## Product Change Notice (PCN)

**Subject:** Site addition of Wafer Process for ATJ-Kumamoto products of RH850/F1L series.

PCN#: [HDL2-0295]  
PC-MCU-A019B/E

## RH850/F1L series

Production identification through label print:

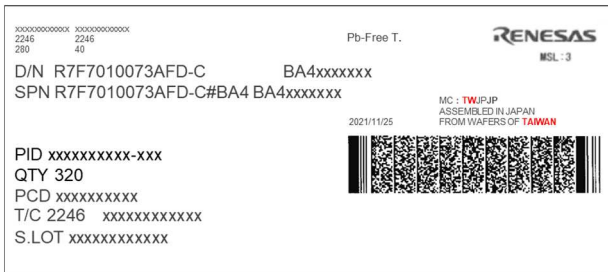
Label Example: R7F7010073AFD-C#BA4 (F1L-2M, 176pin, Cu-wire)

The red characters are different.

TSMC Label Image

Naka Label Image

Production identification through Mark:

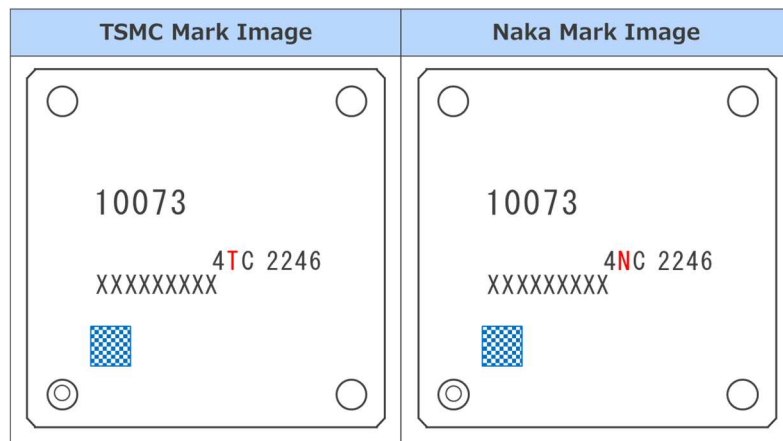
Label Example: R7F7010073AFD-C#BA4 (F1L-2M, 176pin, Cu-wire)

The red character is different.

■ : PKG-ID
